Proposal #34: 9295-00-70, WISC 2026155
Shawano - STH 29
STH 22 to Whitnee Way
CTH BE
Shawano County

Letting of January 13, 2026

This is Addendum No. 01, which provides for the following:

Addendum No. 01
ID 9295-00-70
Revised Sheet 11
January 6, 2026

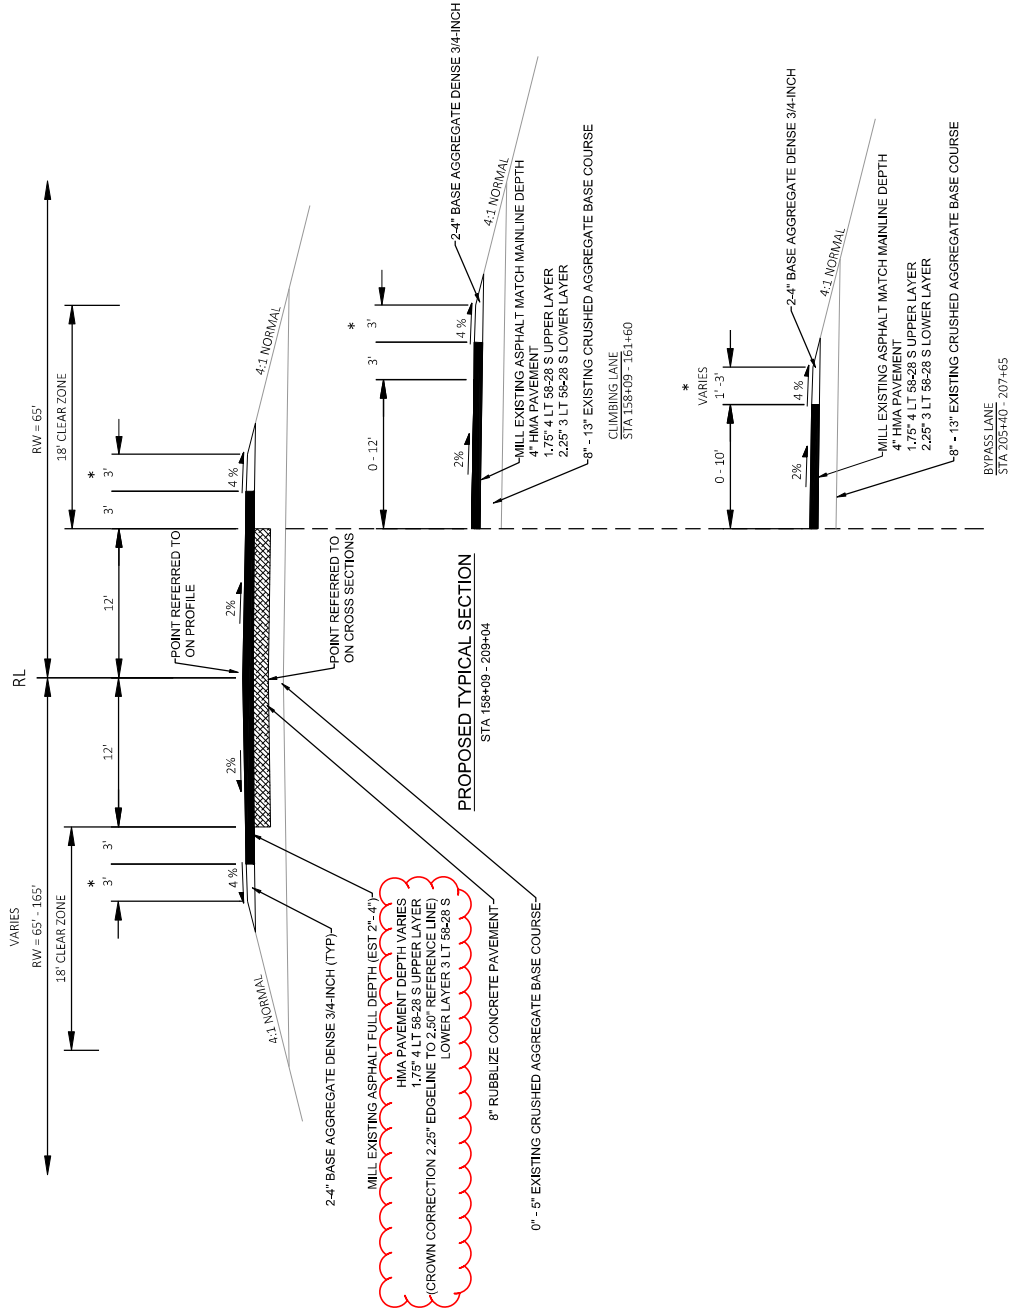
Revised Plan Sheets	
Plan Sheet	Plan Sheet Title (brief description of changes to sheet)
11	Typical Sections (Revised typical section for rubblizing to reflect slope correction to be completed with additional lower layer asphalt material)
27	Miscellaneous Quantities (removed 1 1/4" base aggregate dense from table)
28	Miscellaneous Quantities (revised tonnage for 3LT 58-28 S and revised PWL Mixture Use Table)

* PROPOSED SHOULDERS ARE NARROWER THAN EXISTING. SEE HORIZONTAL POINT TO THE EXISTING GRAVEL HINGE POINT
